Planning Proposal: 469-483 Balmain Road, Lilyfield

Subject: Comments in response to submissions from Inner West Council and the public in relation to the Planning Proposal for 469-483 Balmain Road, Lilyfield

Figure 2: Public domain plan

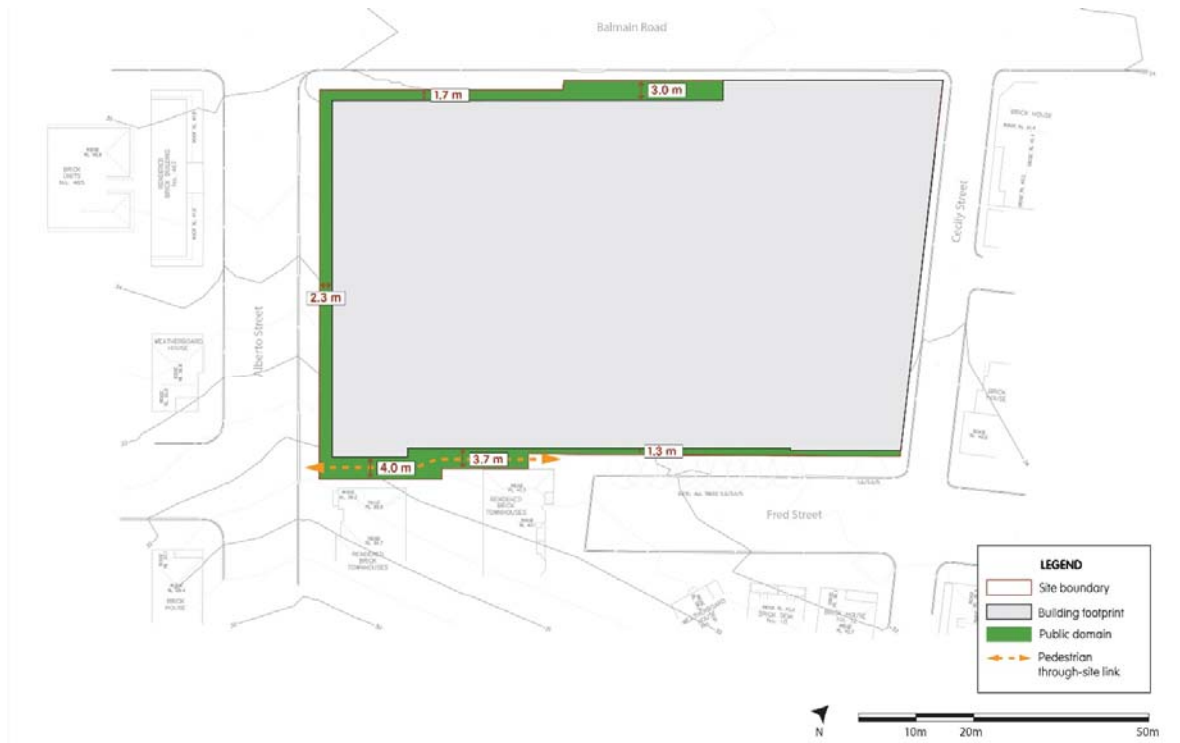
8.	Amend as follows: C1 Widened footpaths to Balmain Road, Alberto Street and Fred Street are to be provided as shown at Figure 2. These areas are to be dedicated to Council at no cost	Agree	Amended as follows: Widened footpaths to Balmain Road, Alberto Street and Fred Street are to be provided as shown at Figure 2. These areas are to be dedicated to Council at no cost.

- C1. Widened footpaths to Balmain Road, Alberto Street and Fred Street are to be provided as shown at Figure 2. These areas are to be dedicated to Council at no cost.
